V2500-A5 SERIES SERIES PROPULSION SERVICE BULLETIN

This document transmits Revision 4 to Service Bulletin NV2500-71-0273

V2500-NAC-71-0273

NACELLE – ENGINE BUILD UNIT (EBU) – REPLACEMENT AND REROUTING OF SEVERAL EBU SYSTEMS
TO ACCOMMODATE THE REROUTING OF THE OIL SCAVENGE TUBES

Installation of the Fire Detection Harness (System A)
 Figure 11, Sheet 1 of 5

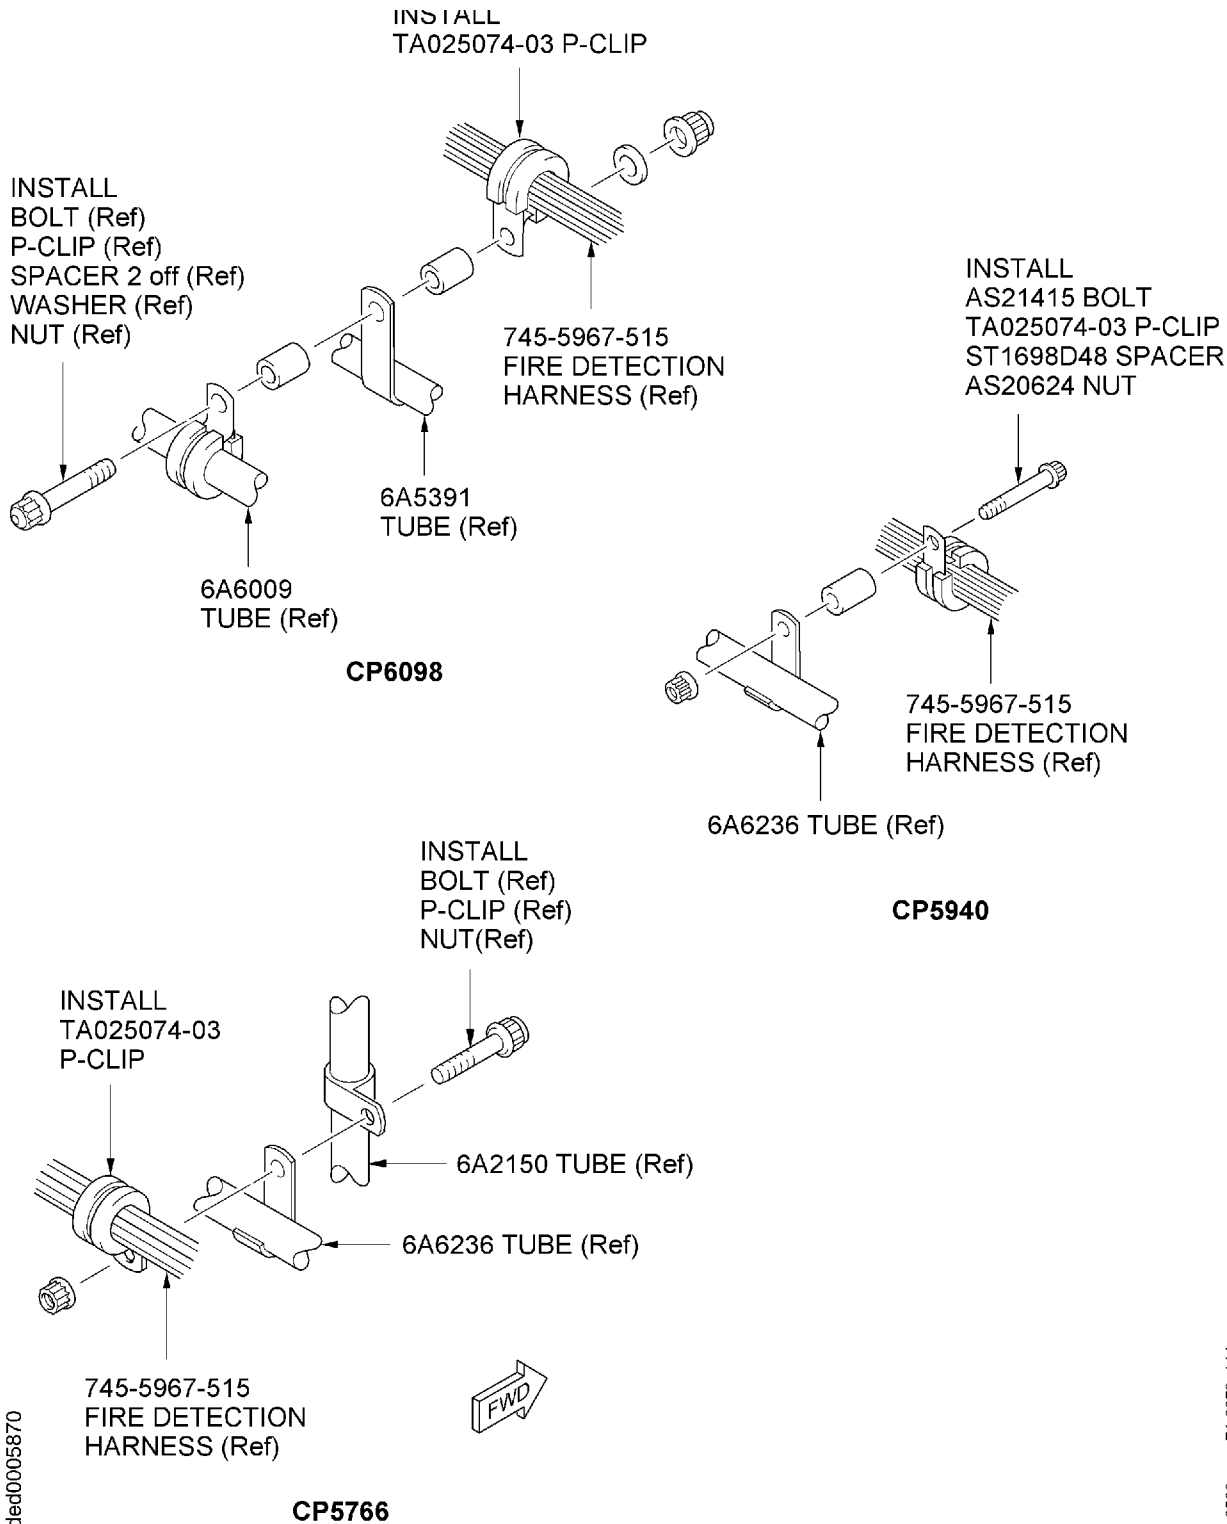
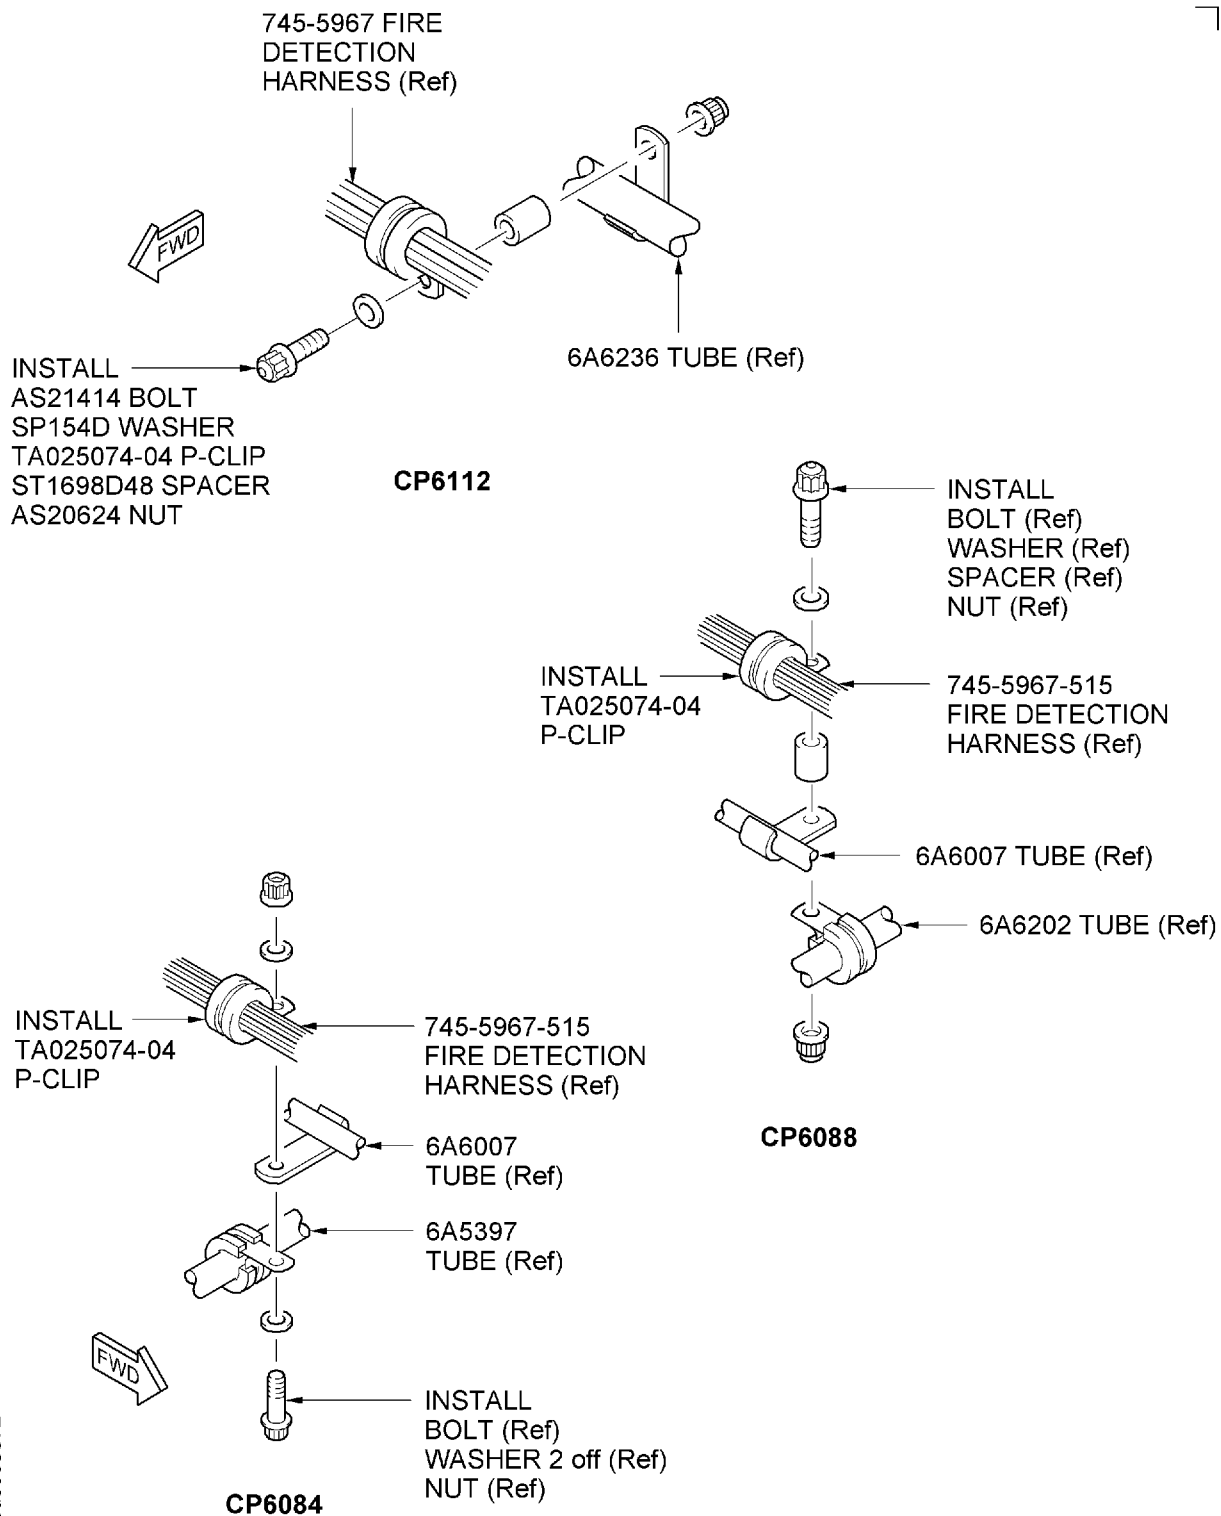
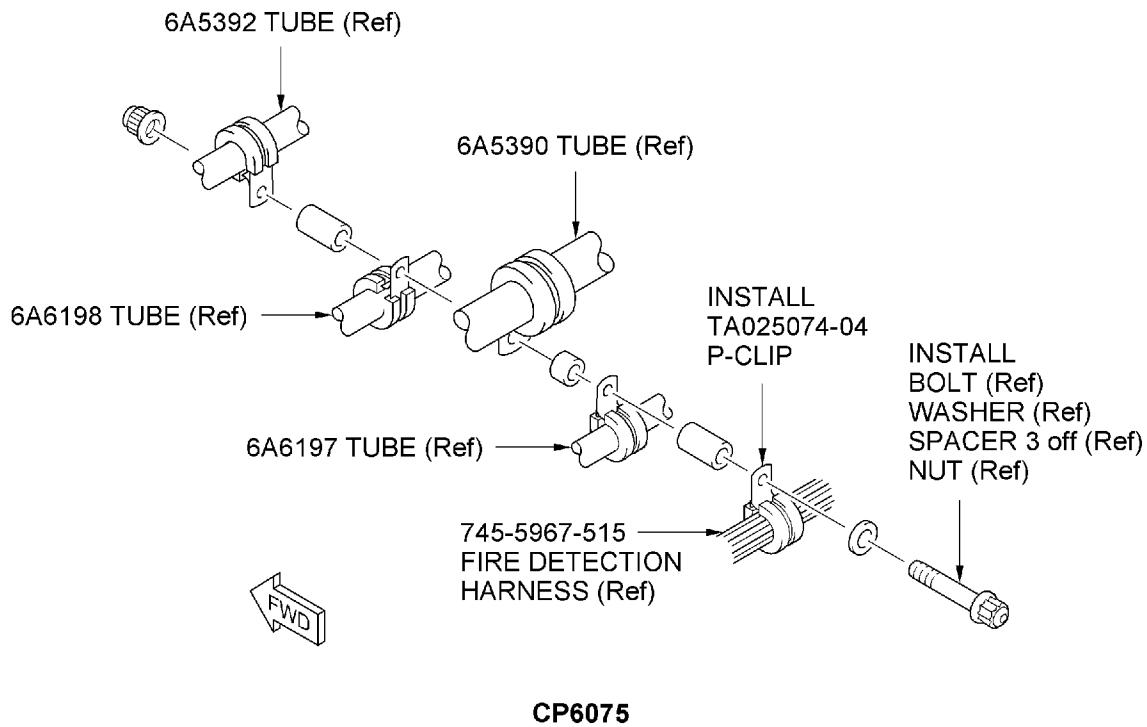
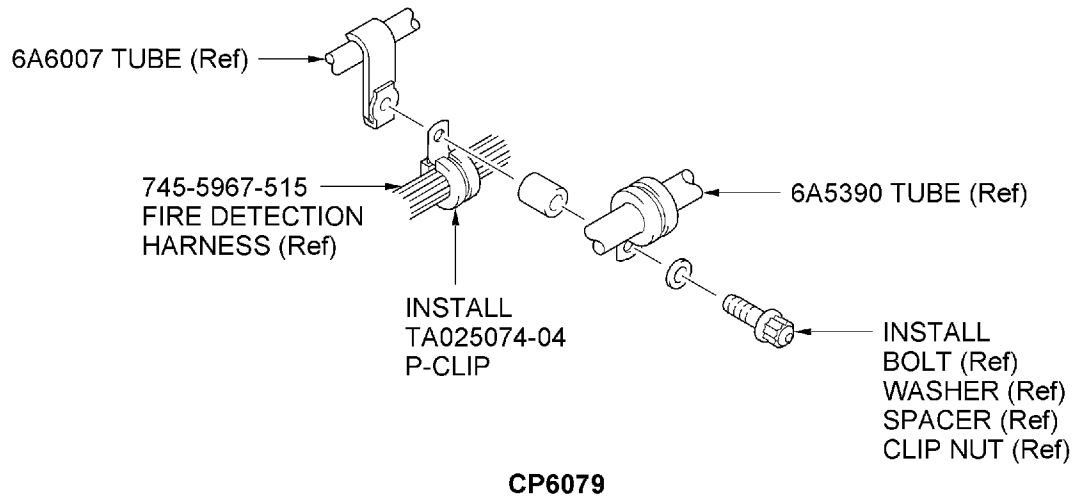
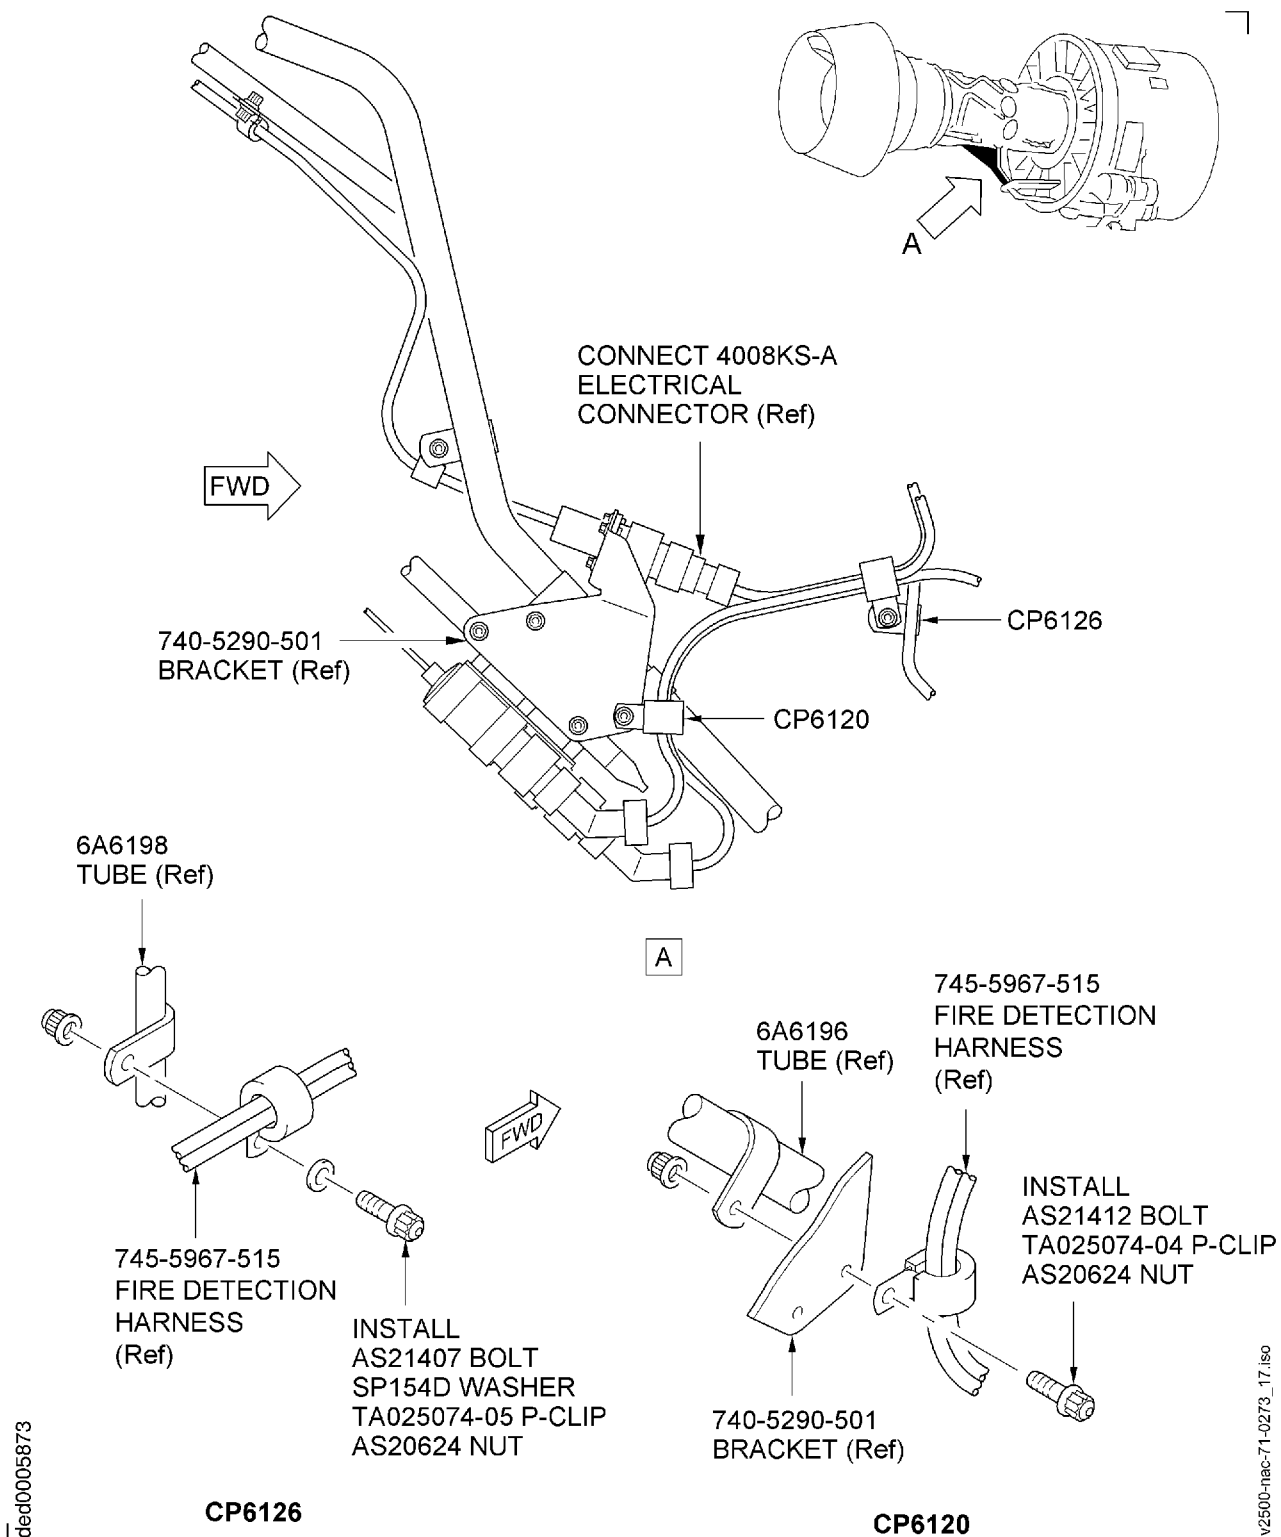
- (e) CP5648 - Attach the Harness to the 6A6236 Tube, the 6A5012 Tube, the Bracket and the 6A6010 Tube with the TA025074-05 P-Clip.
- Refer to Figure 11.

- (h) CP5747 – Attach the Harness.
- (i) CP5648 – Attach the Harness to the 6A6236 Tube, the 6A5012 Tube, the Bracket and the 6A6010 Tube with the TA025074-05 P-Clip. Refer to Figure 11. Lubricate all Clipping Point Bolts and Nuts with Engine Oil CoMat 10-039 or CoMat 10-040.

| <p>(l) CP5648 - Attach the Harness to the 6A6236 Tube, the 6A5012 Tube, the Bracket and the 6A6010 Tube with the TA025074-05 P-Clip.</p> | <p>Refer to Figure 11.

| (m) CP5648 – Attach the Harness to the 6A6236 Tube, the 6A5012 Tube, the Bracket and the 6A6010 Tube with the TA025074-05 P-Clip | Refer to Figure 11.

Partial Installation of the Fire Detection Harness (System A)
Figure 12, Sheet 1 of 2

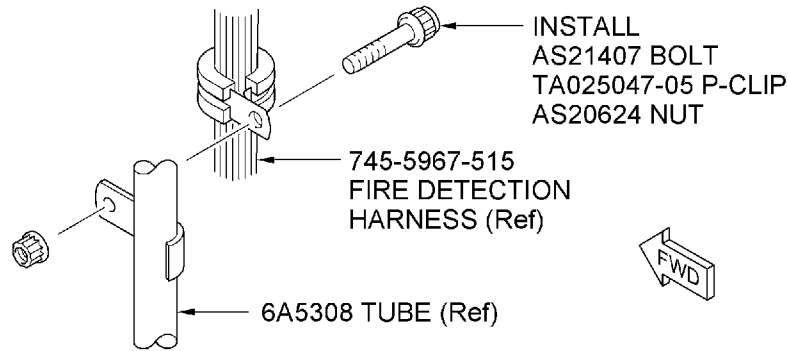
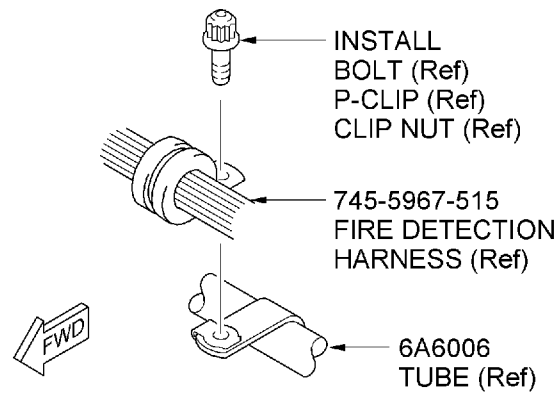
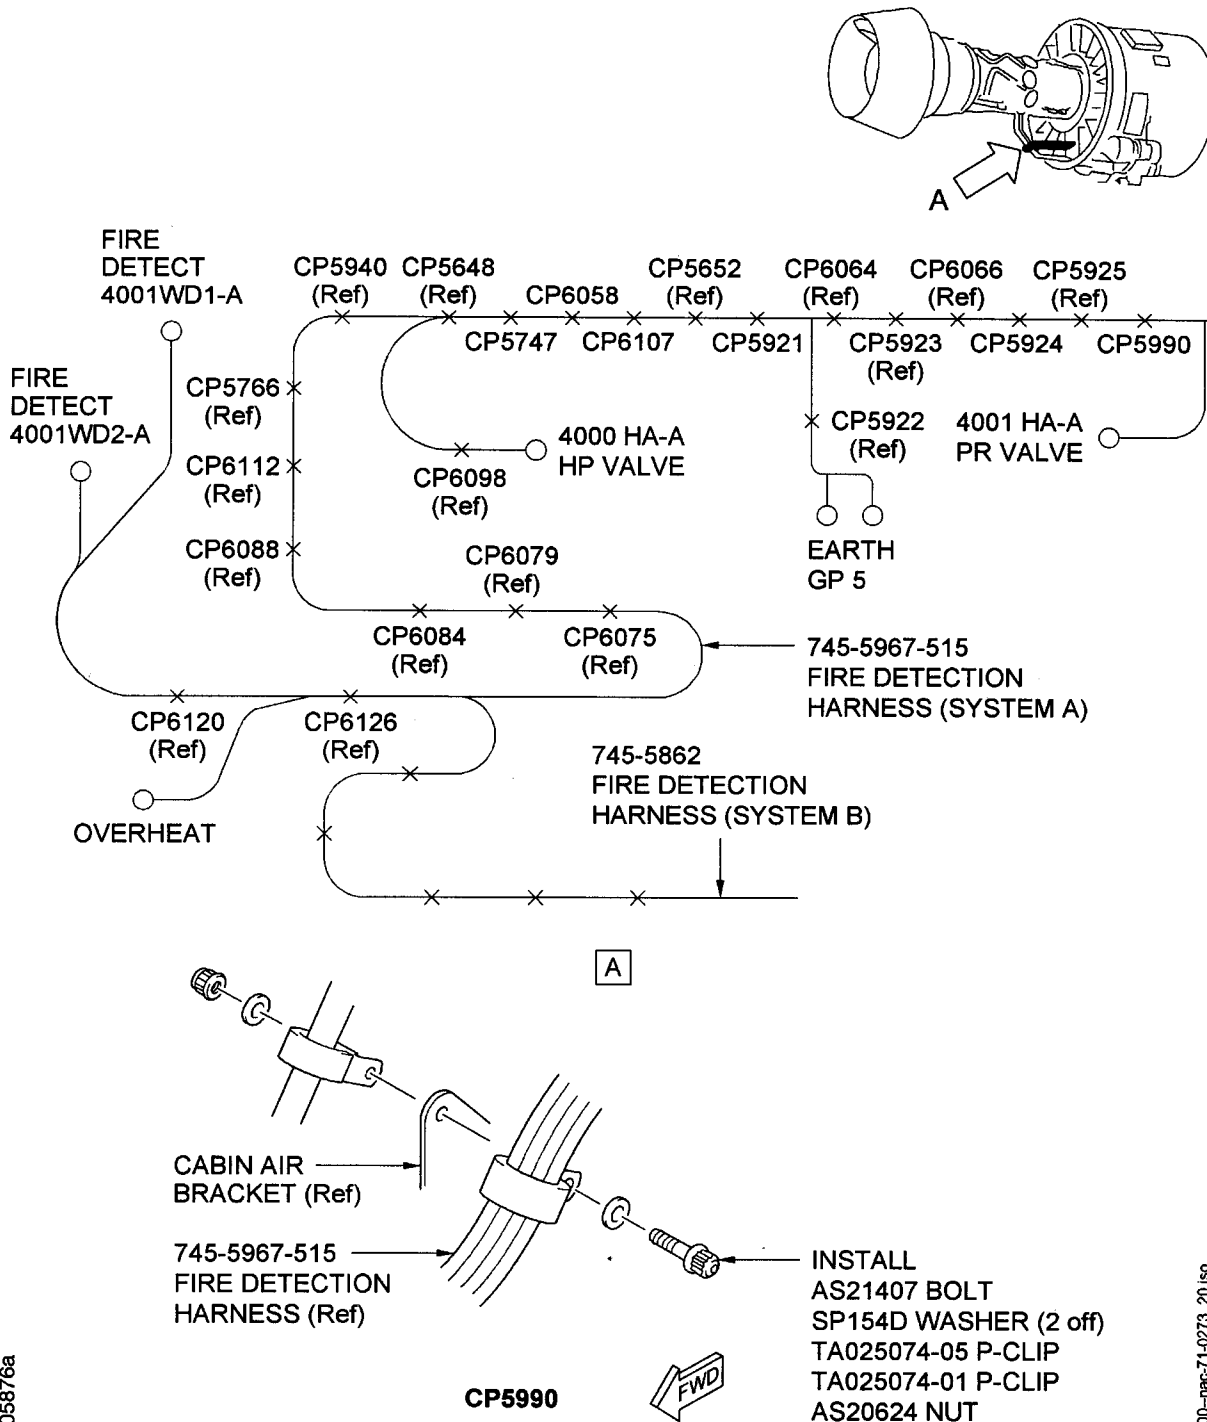
| <p>(e) CP5924 - Attach the Harness to the 6A5308 Tube with the TA025074-05 P-Clip, the AS21414 Bolt the SP154D Washer, the ST1698D48 Spacer and the AS20624 Nut.</p> | <p>Refer to Figure 12.
| <p>(g) CP5921 - Attach the Harness to the 6A5308 Tube with the TA025074-05 P-Clip, the AS21407 Bolt and the AS20624 Nut.</p> | <p>Refer to Figure 12.
| <p>(i) CP5763 - Attach the Harness.</p> | <p>Refer to Figure 12.</p> |
